Work Order ID 104559

**D3303-041 HEAD REST**

DESIGN <i>[Signature]</i>	DRAWN BY <i>[Signature]</i>	DART AEROSPACE LTD HAWKESBURY, ONTARIO, CANADA	
CHECKED <i>PH</i>	APPROVED <i>[Signature]</i>	DRAWING NO. D3303	REV. B SHEET 2 OF 4
DATE 06.08.17		TITLE HEAD REST	SCALE 1:2

DRAWING NO D3303		TITLE HEAD REST		REV. B		DART AEROSPACE LTD ENGINEERING ORDER		PART NO D3303-B-1		SHEET NO. SHEET 1 OF 1		SCALE N/A	
DRAWN AJS		CHECKED [Signature]		MFG. APPR. [Signature]		APPROVED [Signature]		DE APPR. [Signature]					
DATE 08.10.15		DATE 08.10.15		DATE 08/10/16		DATE 08/10/16		DATE 08/10/16		DATE 08/10/16

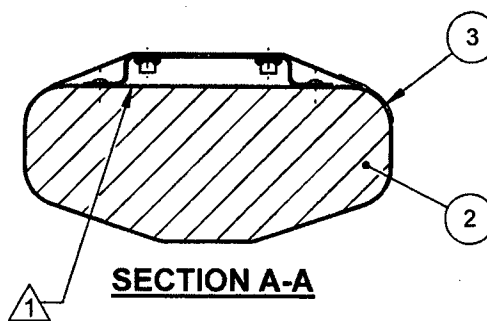
SHEET 1 ADD 1300L ADHESIVE BY 3M TO NOTE 1 AS FOLLOWS:

- 1) BOND D3305-1 FOAM TO D3303-043 BRACKET ASSEMBLY USING 3M 1300 ADHESIVE (0.002" TO 0.010" THICK) IN ACCORDANCE WITH MANUFACTURER'S INSTRUCTIONS

- 1) BOND D3305-1 FOAM TO D3303-043 BRACKET ASSEMBLY USING 3M 1300 OR 1300L ADHESIVE (0.002" TO 0.010" THICK) IN ACCORDANCE WITH MANUFACTURER'S INSTRUCTIONS
